TO:	Emily Wentworth, Town of Hingham	DATE:	March 30, 2016
FROM:	Joe SanClemente, P.E., AICP	HSH PROJECT NO.:	2015151.01
SUBJECT:	Avalon Hingham Shipyard II – 319 Lincoln Street Vanasse Traffic Peer Review – Response to Comments

Howard Stein Hudson (HSH) has prepared this memorandum in response to the comments received on the Avalon Hingham Shipyard II Project from the Town's peer review consultant, Vanasse & Associates, Inc. (VAI) in a memorandum dated March 10, 2016. Since that time the Proponent has reduced the scope of the Project to include just 190 residential units (60 fewer units) and associated adjustments to the site plan. HSH has prepared a technical memorandum documenting the change to the Proposed Project, the reduced traffic impacts, and the proposed mitigation.

Figure D.7. WB-50 Turning Movements from Route 3A WB to Service Aisle/Fire Lane

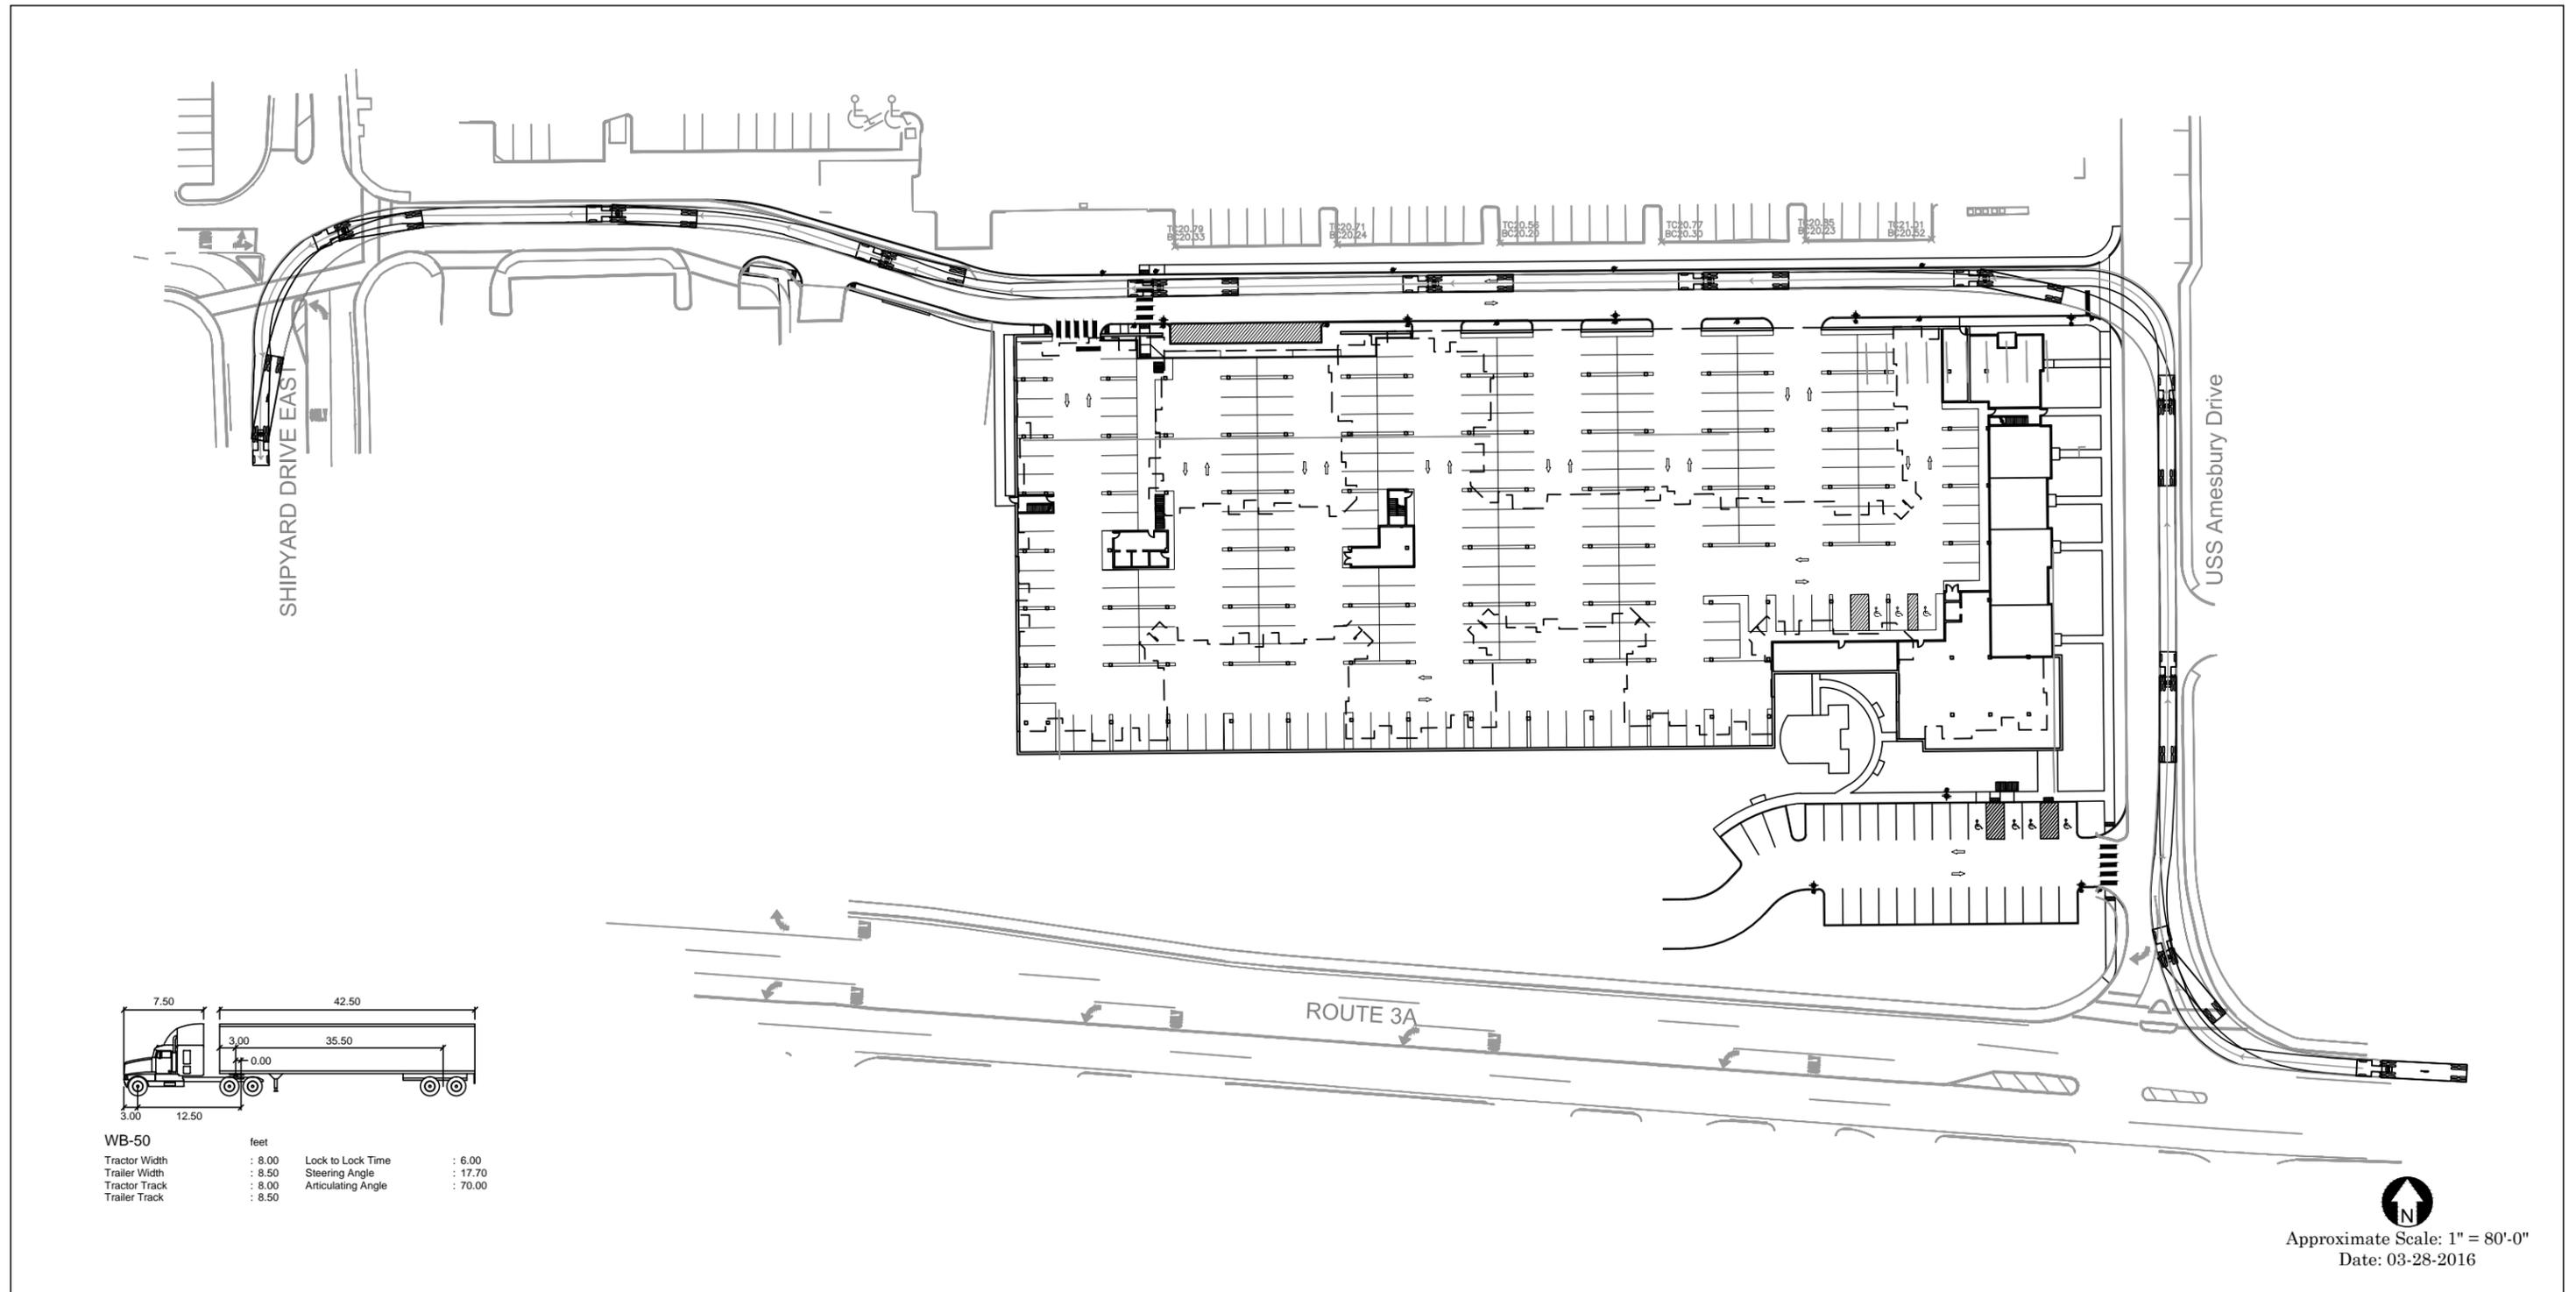
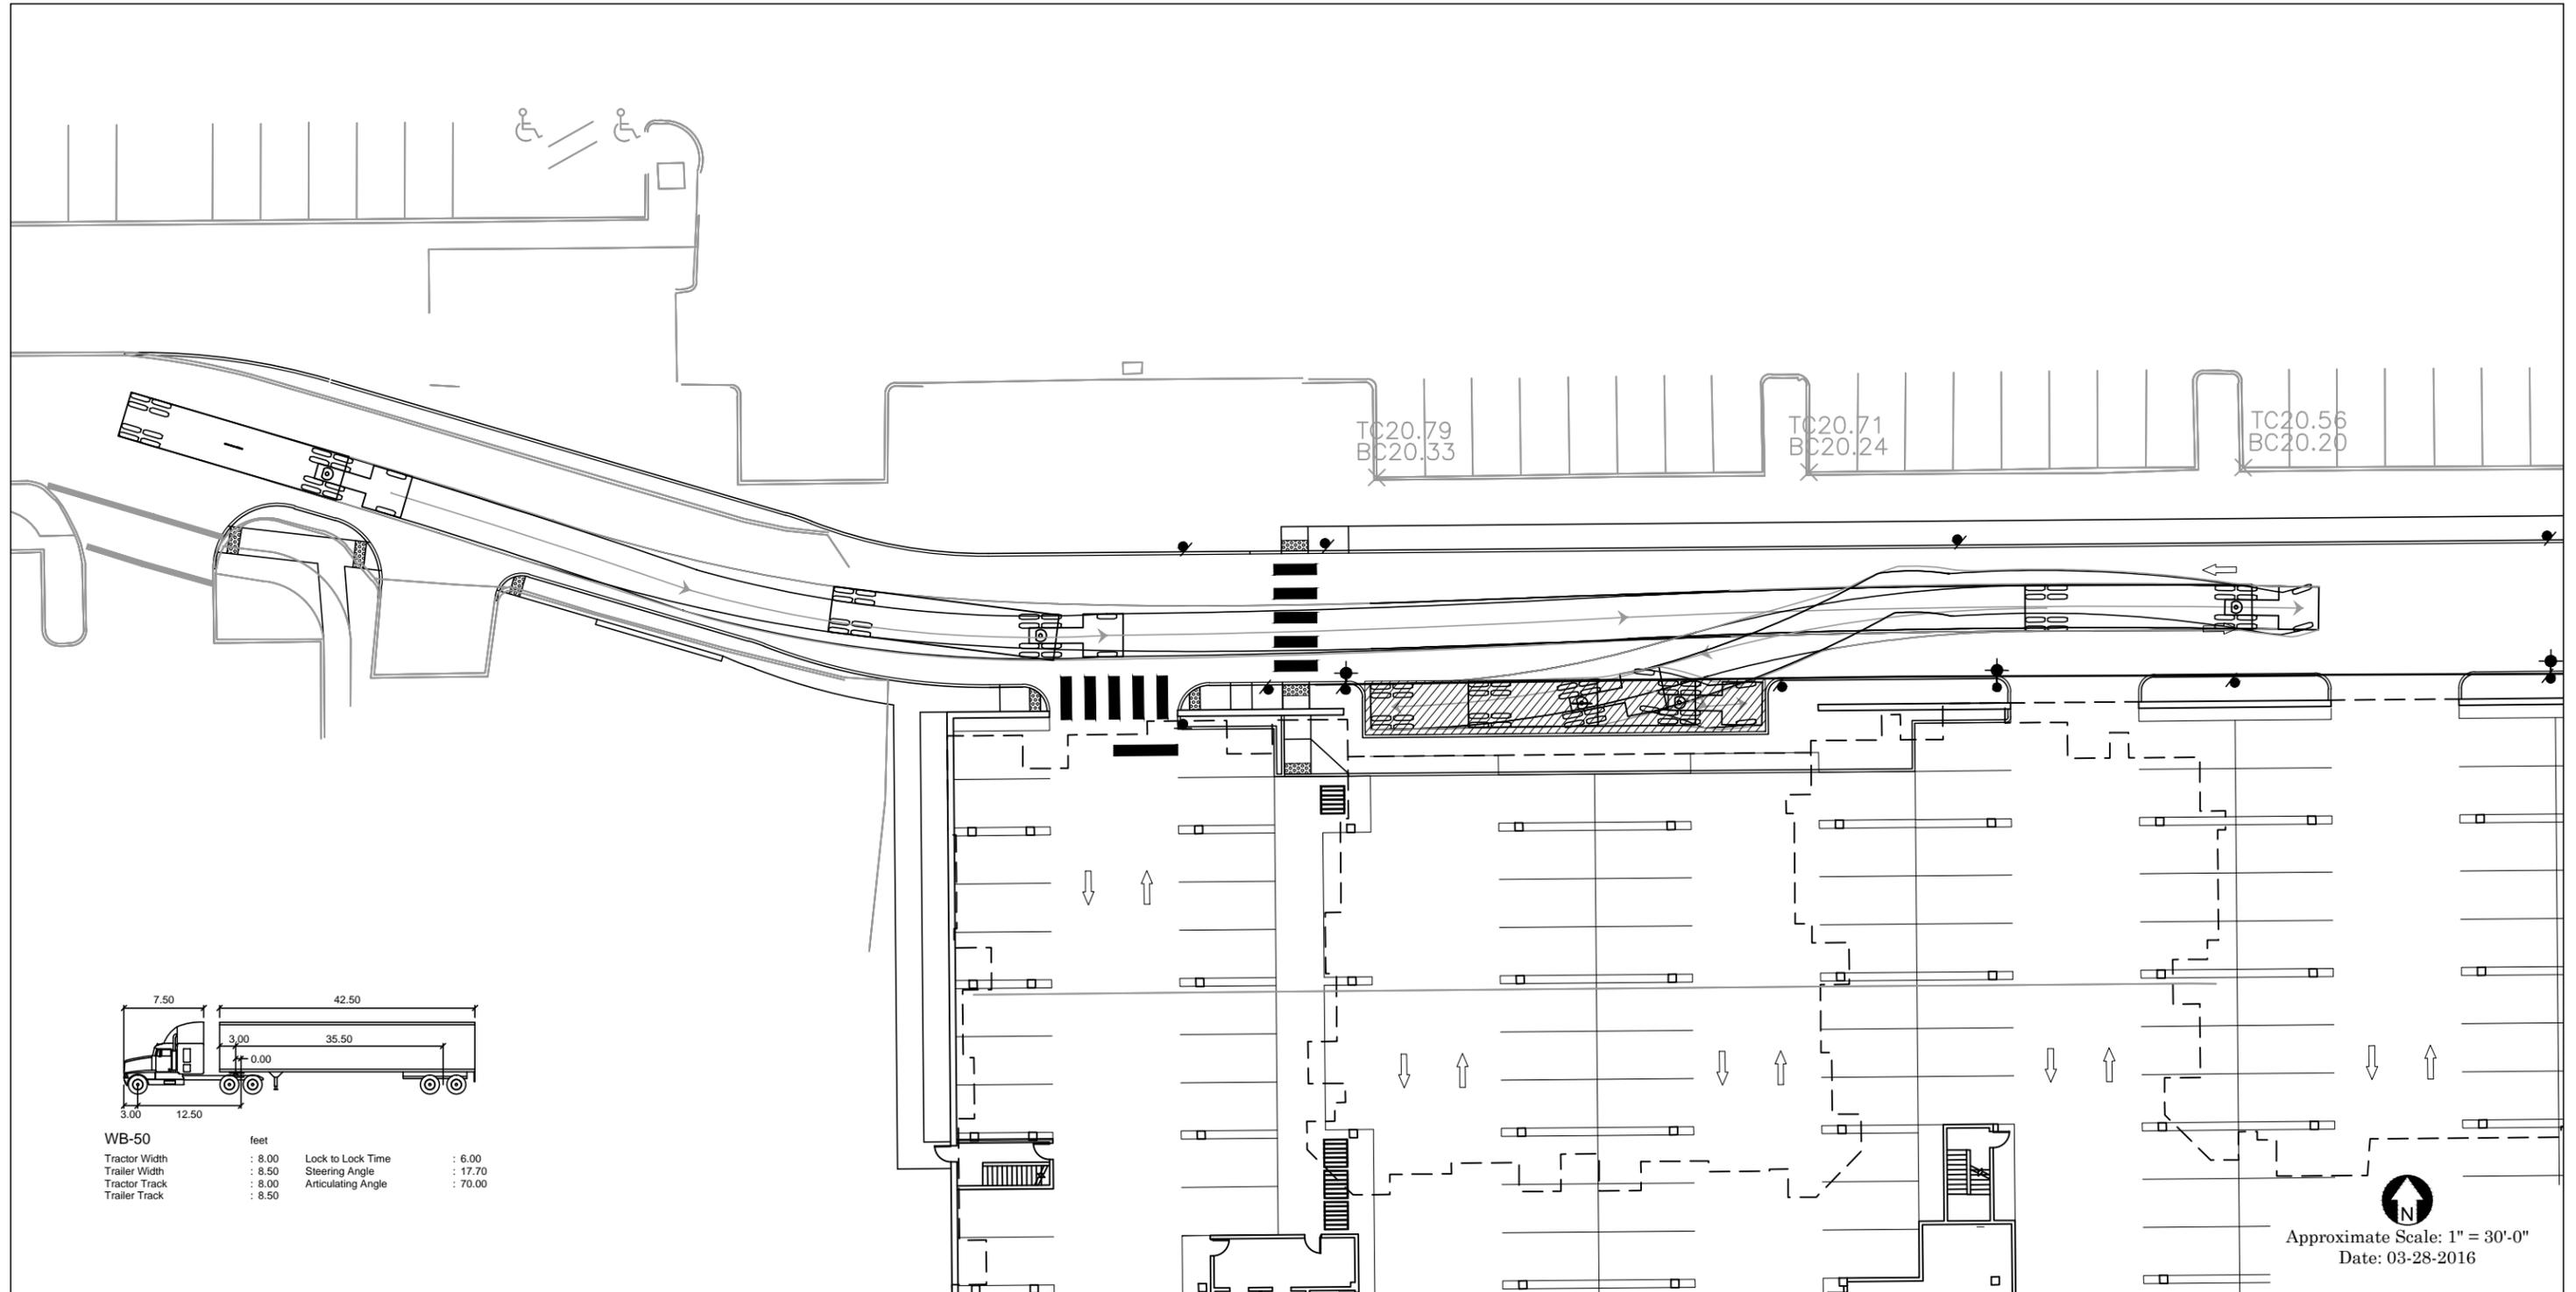
**Comment 1:** The Applicant's engineer provided a truck turning analysis for the Town of Hingham Fire Department design vehicle (tower truck) and an intermediate size tractor semi-trailer combination (WB-50). The turning analysis demonstrated that the subject vehicles can access and circulate within the Project site in an unimpeded manner; however, we note that the fire truck would need to back-up to exit the visitor parking area. The Applicant's engineer should also provide a turning analysis for an SU-30/40 (small delivery/moving vehicle and trash/recycling vehicle) that demonstrates that the subject vehicle can access and stage in the loading areas without blocking the garage access points. In addition, the analysis should also demonstrate the location and maneuvering required to serve the trash/recycling area.

Response 1: See attached truck turning analysis.
